SIB 28 01 24

## SERVICE ACTION: DOUBLE CLUTCH TRANSMISSION REWORK AT TRANSFER CASE (DISASSEMBLE)

This Service Information Bulletin (Revision 2) replaces SI B28 01 24 **dated May 2024**.

U11 (X1 Sports Activity Vehicle)

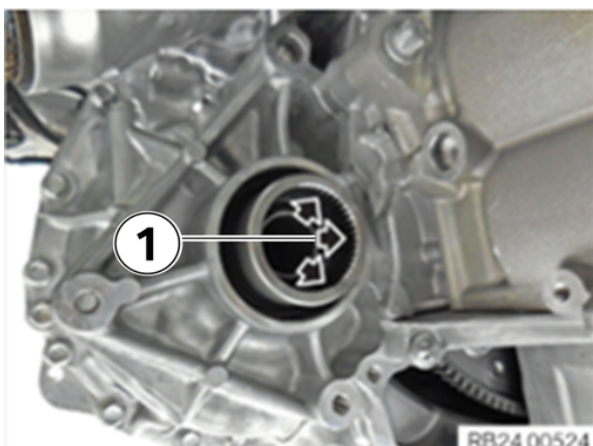
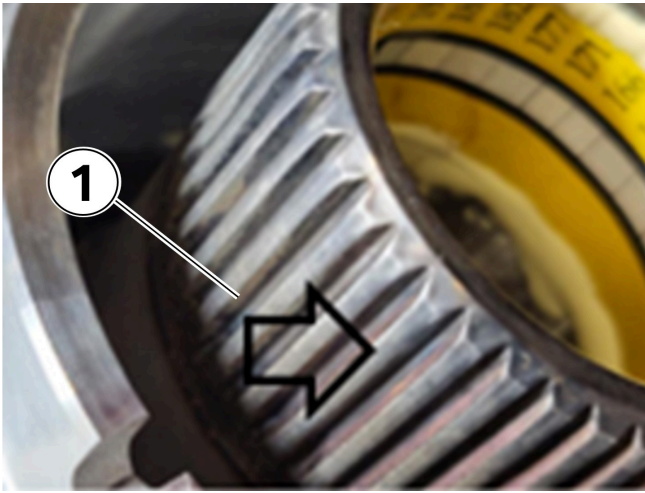
Micro-movements combined with frictional corrosion can increase wear on the longitudinal splined connection between the double clutch transmission (DCT) and the transfer box.

Rework the surface mating area on the double clutch transmission (DCT) at the transfer case.

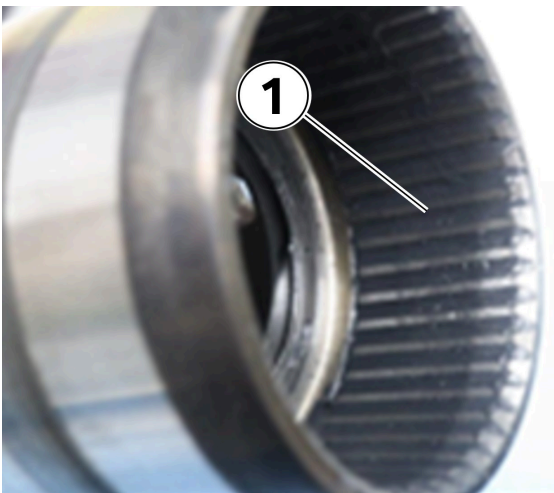
Clean the inner splines of the DCT (1) with brake cleaner and a brass wire brush (nothing harder than brass)

Clean the outer splines of the transfer case with brake cleaner and a brass wire brush (1) (nothing harder than brass)

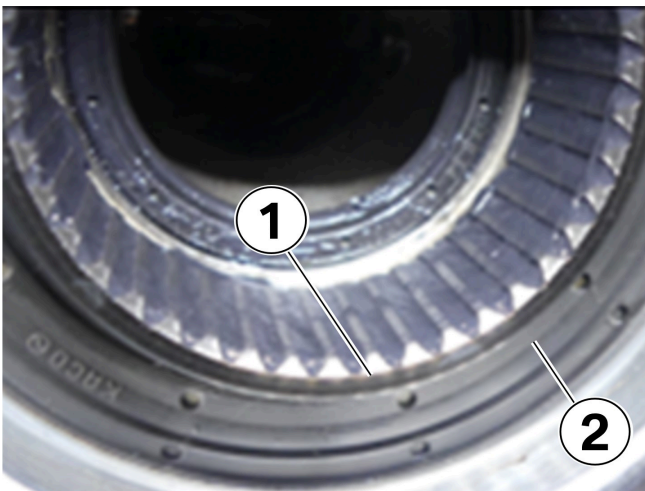
Apply grease (MI-Setral-43N) evenly to the inside of the input flange so that the spaces between the teeth are filled (1).

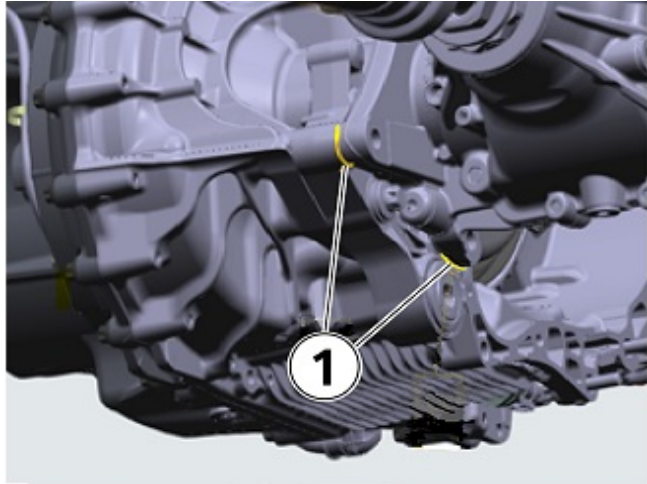
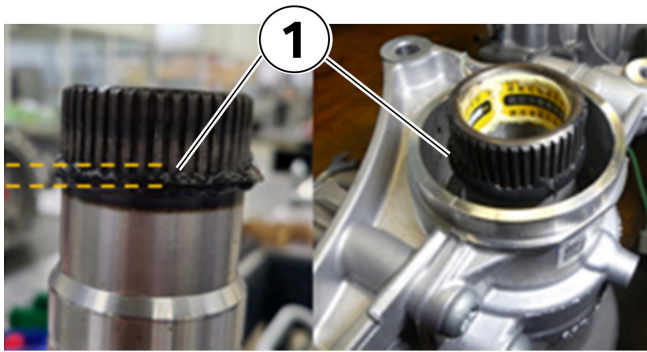
Clean off excess grease from the end face of the gear (1). Ensure the grease makes no contact with the shaft seal (2).

Apply a continuous bead of Loctite 5970 to the input shaft of the transfer case (1). The transfer case must be installed immediately after applying the Loctite.

Install special washers (1) between the stabilizer link and the transfer case before bolting the transfer case to the DCT.
